# Addendum 6

Sugarcreek Water Treatment Plant and Wellfield Improvements

**Addendum No. 6**  
**June 3, 2022**

SCALE: 1/2" = 1'-0"

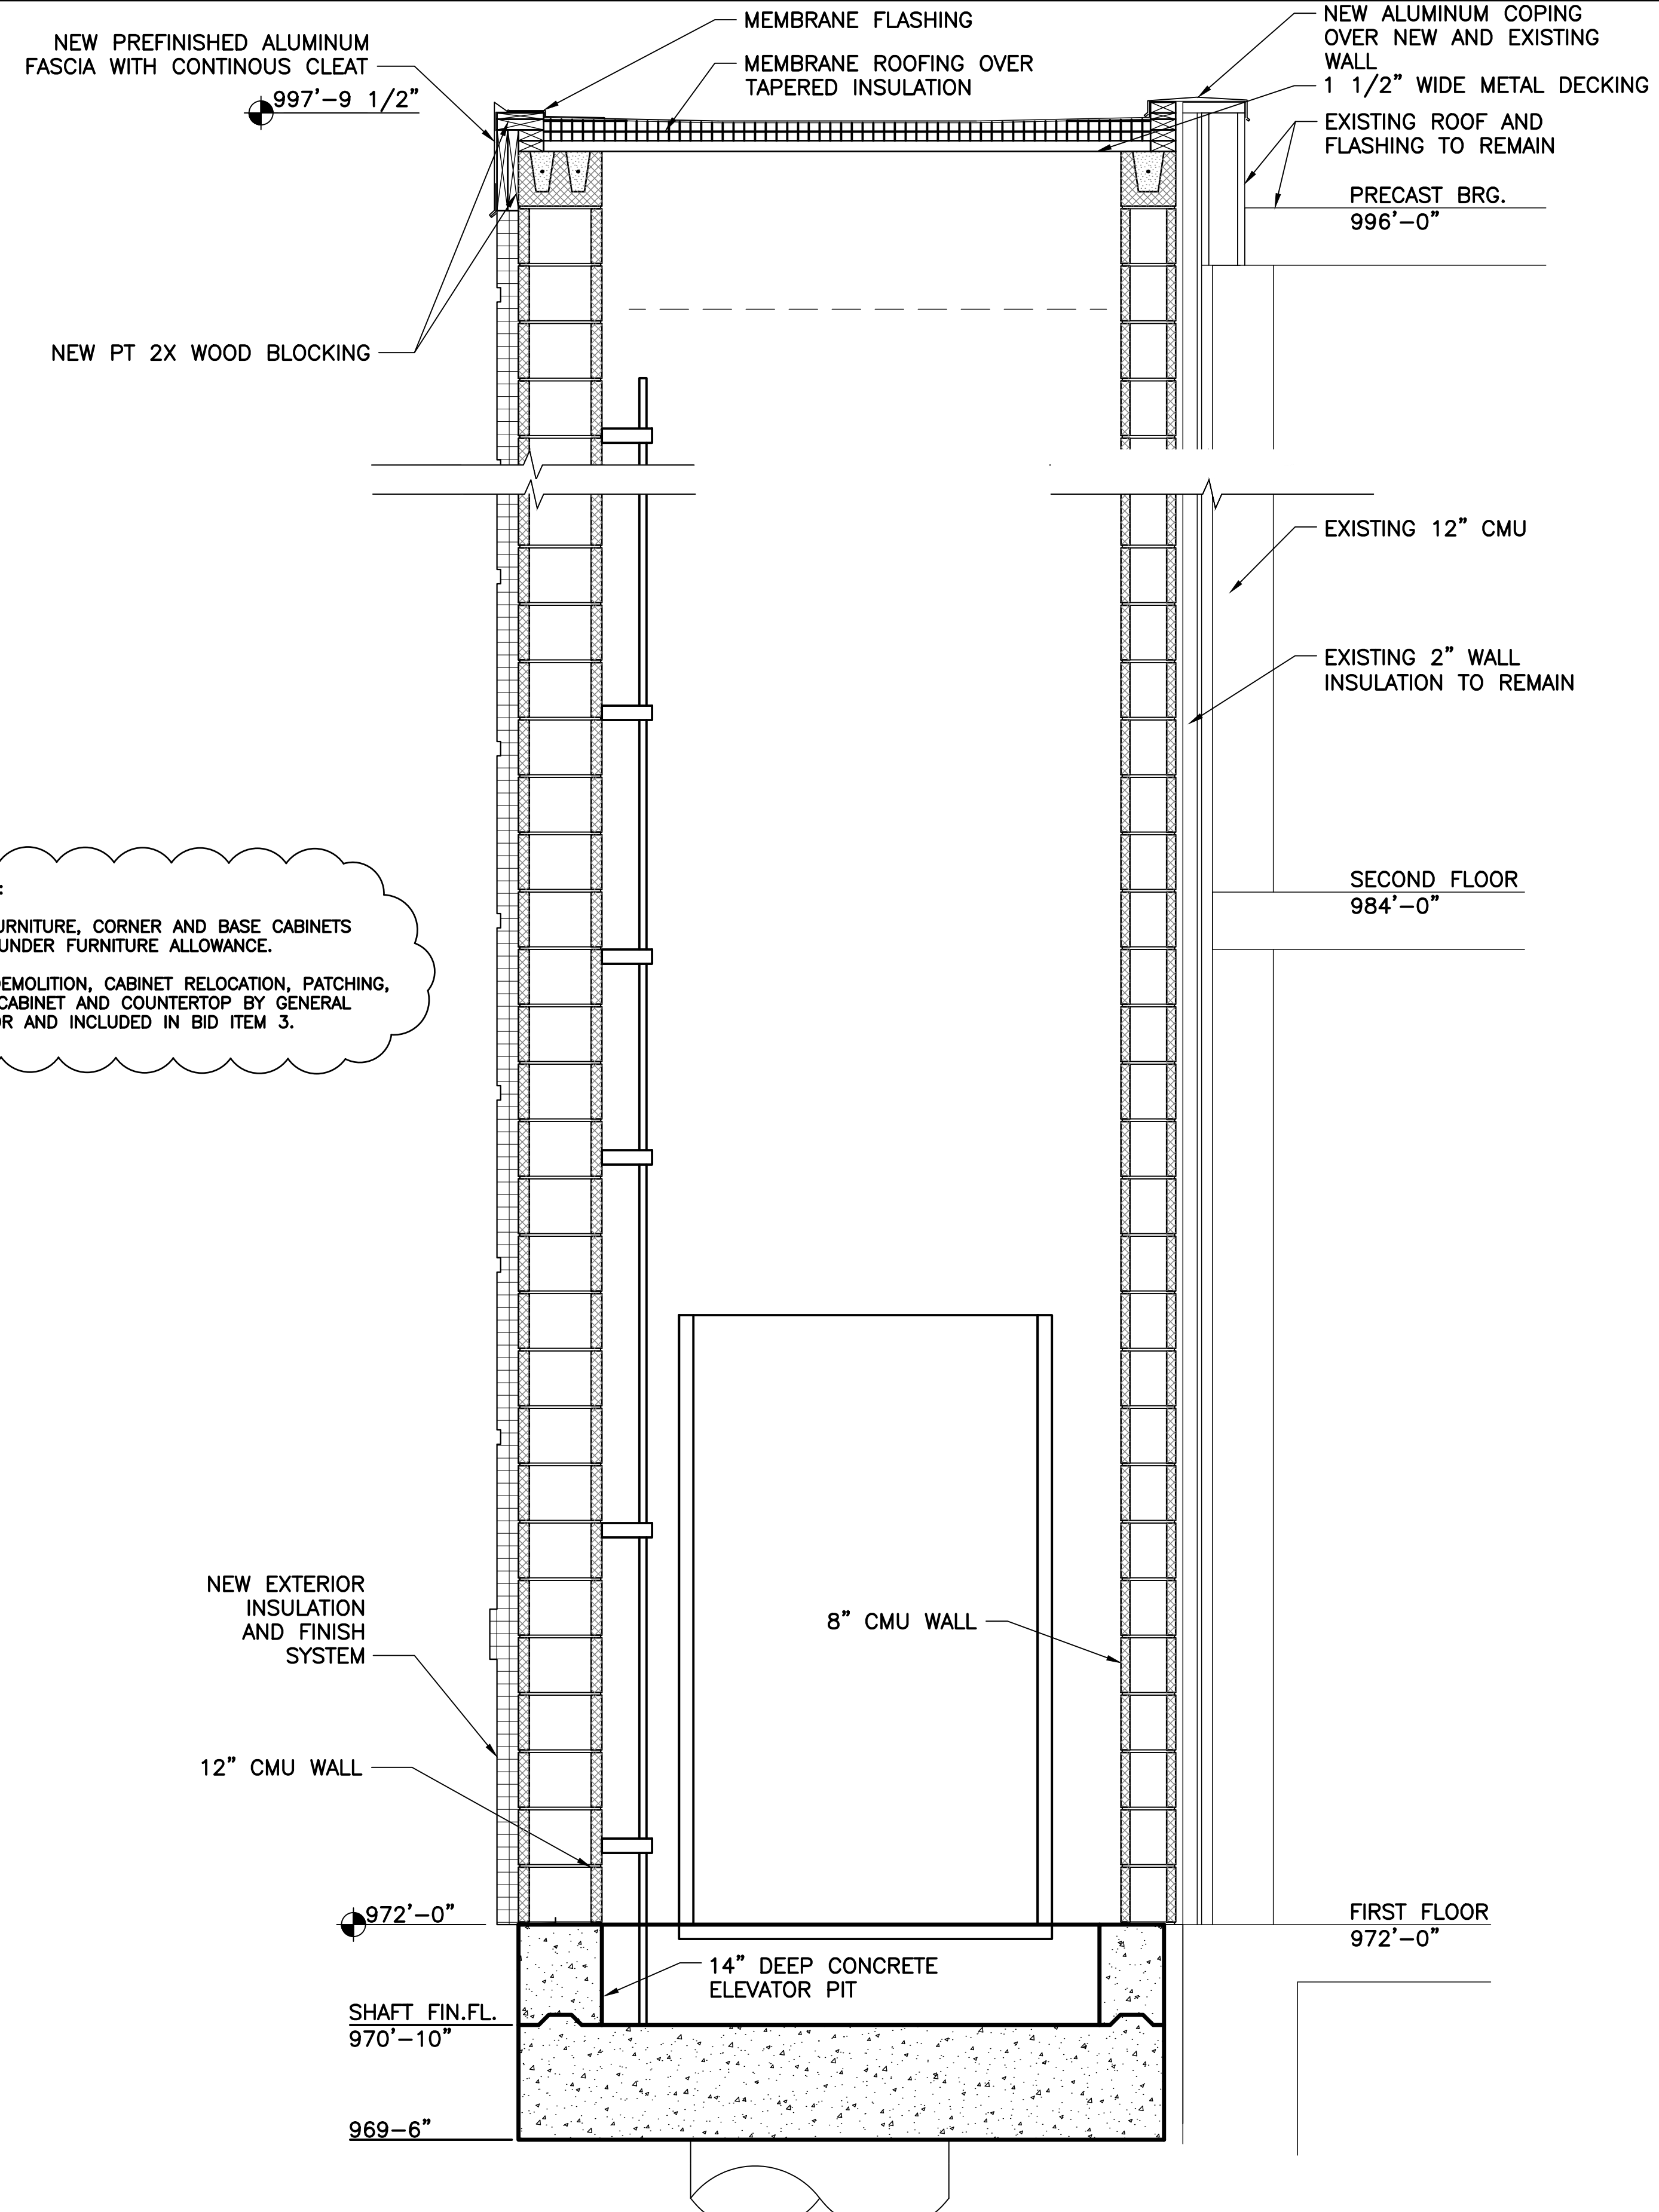
- ADD New Work Coded Note 12, “12. Clean and buff finish existing aluminum handrail and spindles.”
36. **Sheet A-12, Main Building Architectural Elevator Wall Section.** ADD attached Sketch A-12. Provides elevation of new casework in Laboratory Room 203.
